UNITED STATES  
NUCLEAR REGULATORY COMMISSION

**SUBJECT: SUMMARY OF MEETING WITH THE NUCLEAR ENERGY INSTITUTE (NEI) TO DISCUSS STAFF'S REQUEST FOR ADDITIONAL INFORMATION (RAI) ON ENVIRONMENTAL ASSISTED FATIGUE**

**REQUEST FOR ADDITIONAL INFORMATION  
FOR PROPOSED INTERIM STAFF GUIDANCE (ISG)  
FOR FATIGUE ENVIRONMENTAL EFFECTS**

## Discussion of Response to RAI on ISG-11

## Original LAS Data (MRP-49) Plotted vs. MRP-74 Modified Equations

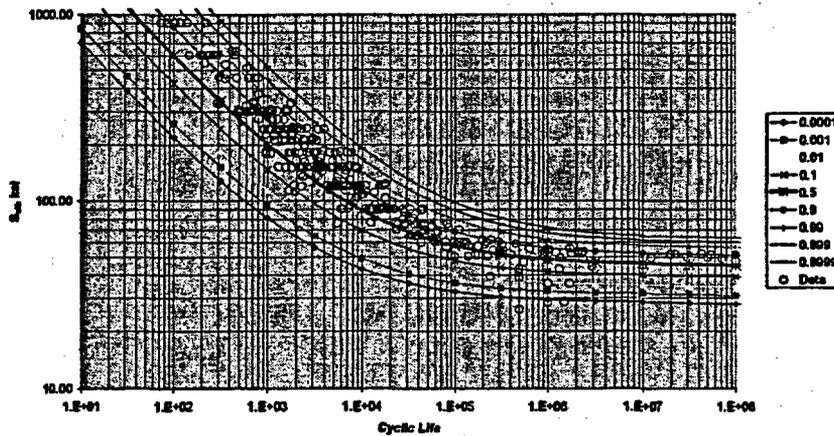
- *The revised probabilistic fatigue curves do not appear consistent with the data for carbon and low alloy steels. For example, compare probabilistic curves developed using the EPRI assumption for the standard deviation of the endurance limit with the data presented in Figure 14 of Attachment 1 of the submittal.*

- Most of data are above the mean curve
- Only a few points below the mean curve
- Detailed review of data shows low points resulted from high R-ratio testing
- Correction for mean stress effects shows that observed low points are within scatter band for remainder of data
- Therefore, the standard deviation chosen to represent the data is conservative

## Mean Stress Effects

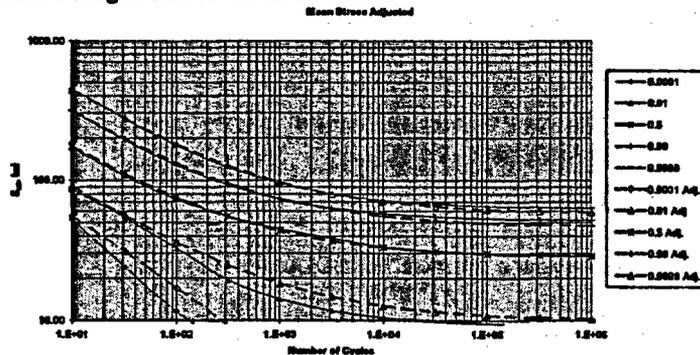
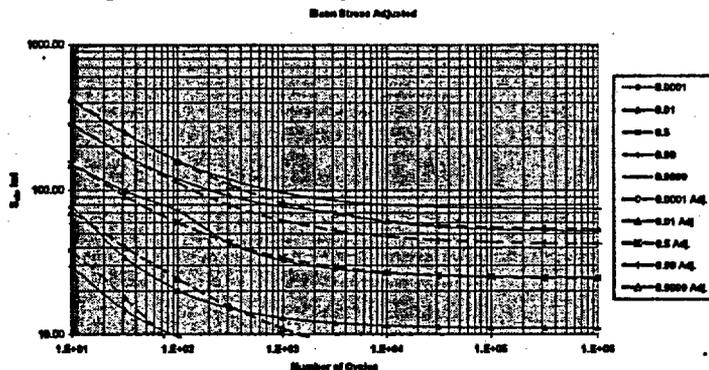
- The strain thresholds are discussed on page 26 of NUREG/CR-6717. NUREG/CR-6717 indicates that, after mean stress effects are taken into account, a threshold strain amplitude of 0.07% provides a 90% confidence level for both carbon and low alloy steels. As discussed previously, the threshold strain is approximately 20% higher than the endurance limit of the steel. Consequently, the 10 percent probabilistic fatigue curve should approach a strain amplitude of approximately 0.06% at  $10E6$  cycles. The 10 percent probability curve shown in Figure 3-11 of the EPRI report is not consistent with a strain of 0.06%. Discuss this discrepancy between Figure 3-11 of the EPRI report and the data assessment contained in NUREG/CR-6717.

- The EPRI report, page 3-11, provides a procedure to account for mean stress effects. Show how this procedure was implemented in the evaluations presented in Chapter 4 of the report. Discuss the consistency of the mean stress adjustment used in the Chapter 4 evaluations with the mean stress adjustment discussed in NUREG/CR-6717.

- Response
  - Approach used in MRP-74 provides a more rigorous approach for mean stress adjustment
- In NUREG/CR-6335 and -6717, a modified Goodman approach was used to adjust fatigue curves down; implemented in modified curve fit equations

- Both arrive at essentially the same results as shown on the following pages for  $S_{uts} = 100$  ksi and  $S_{ys} = 70$  ksi

- Approach used in MRP-74 is more conservative at low quantiles - correction made to modified fatigue curve not to mean

- Curves are comparable

## Response to Question 5

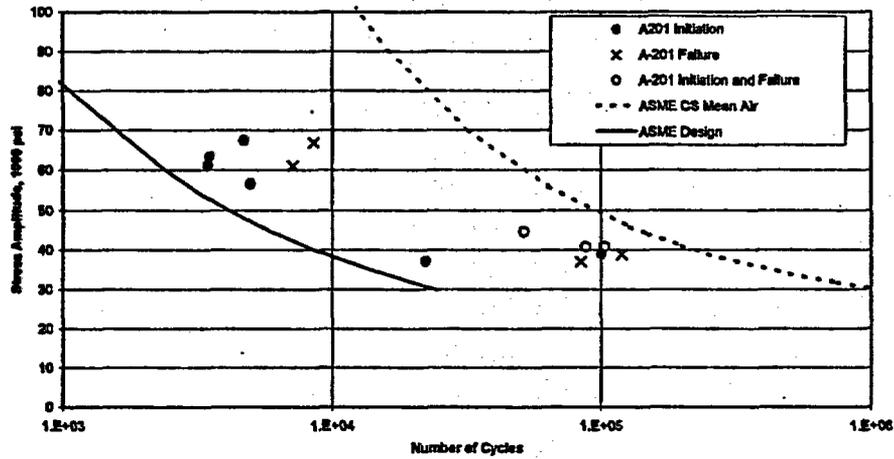
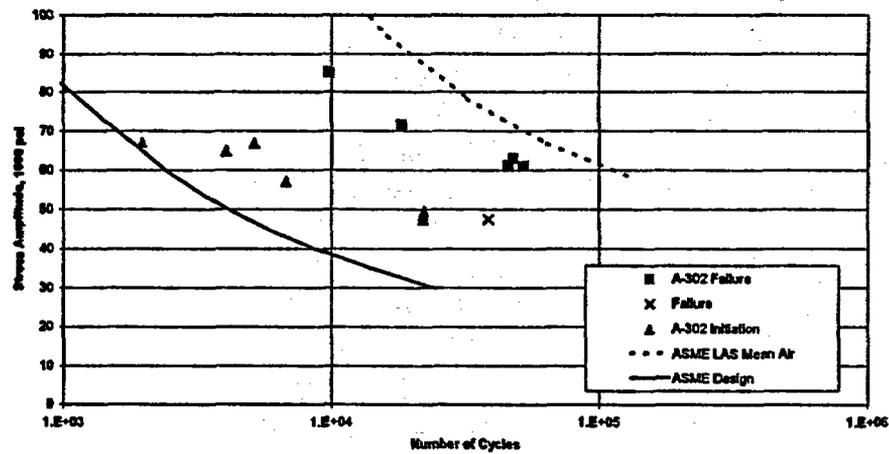
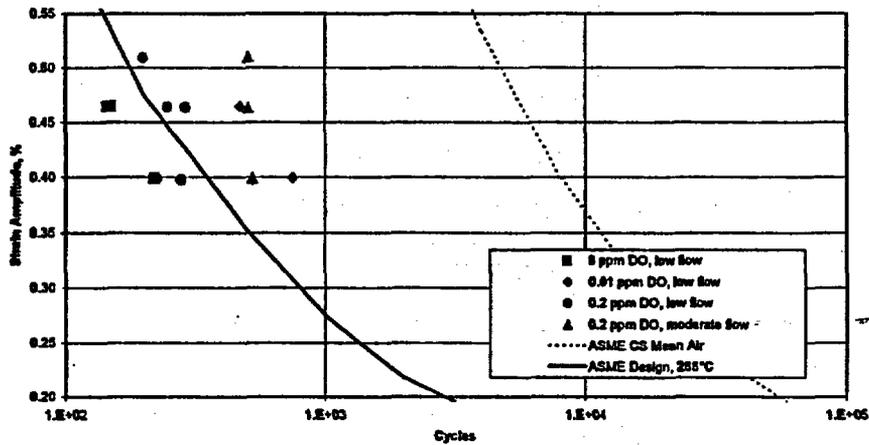
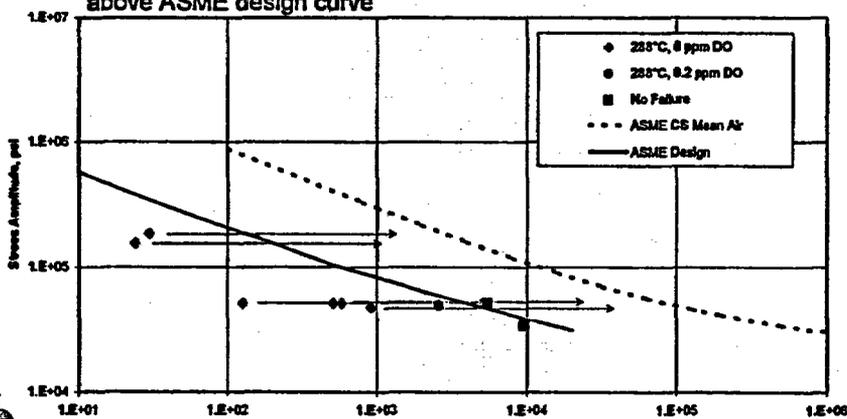
- Question
  - *The submittal references the evaluation of the component fatigue tests contained in EPRI Report MRP-49. The evaluation of the component fatigue test data is similar to the evaluation contained in EPRI Technical Report, "Guidelines for Addressing Fatigue Environmental Effects in a License Renewal Application (MRP-47)," Draft Revision G dated June 5, 2001. This report was submitted to the NRC by NEI letter dated July 31, 2001. The staff transmitted a request for additional information regarding the evaluation of the component fatigue tests by letter dated June 26, 2002. The staff has not received a response to its request for additional information. Indicate how the relevant June 26, 2002, staff comments have been addressed in the test data evaluation contained in EPRI Report MRP-49.*

- **MRP-47 RAI on Evaluation of Component Fatigue Tests**
  - *The evaluation of component tests did not include the data from the Southwest Research Institute tests on vessels that is shown on page 4 of NUREG/CR-6583. This test data does not appear to support conclusion regarding the maximum effect of size and surface finish on fatigue life. Explain why this data was omitted from the evaluation. Provide an assessment of the Southwest Research Institute using the same method used to assess the KWU tube tests and the General Electric pipe tests.*

- Appendix C of MRP-47 evaluated preliminary component-scale fatigue data with at least one surface in contact with oxygenated water at temperature
- MRP-49 included component-scale fatigue data with at least one surface in contact with oxygenated water at room temperature – the same PVRC/SWRI carbon and low-alloy steel pressure vessel fatigue data shown on page 4 of NUREG/CR-6583
- The evaluation process for these pressure vessel fatigue test data was identical to the process used to evaluate the KWU 180-degree bend fatigue tests and the General Electric pipe tests. The results for all three sets of component fatigue tests are completely consistent

- Tests performed on sample with 11 welds *in series*
  - Only first failure reported; remaining welds exhibited higher fatigue life
  - Tests performed under typical BWR environmental conditions failed at or above ASME design curve

- Results from the PVRC tests were reported in MRP-49 (Figures 2-35 and 2-36). While some of the crack initiation results approach the ASME Code fatigue design curve, none of the cycles to crack initiation were less than the design curve. Since the intent of the ASME Code fatigue design curves is to predict the mean line for crack initiation in actual vessels, these tests demonstrate that the margins used by the ASME in developing the design curves are conservative, even with exposure of vessel inner surfaces to oxygenated water.
- Figure 2 from NUREG/CR-6583 shows essentially the same data, but does not show the comparison between the ASME design curve and air curve, so that the reader may have difficulty determining whether the data points are located appropriately or not.
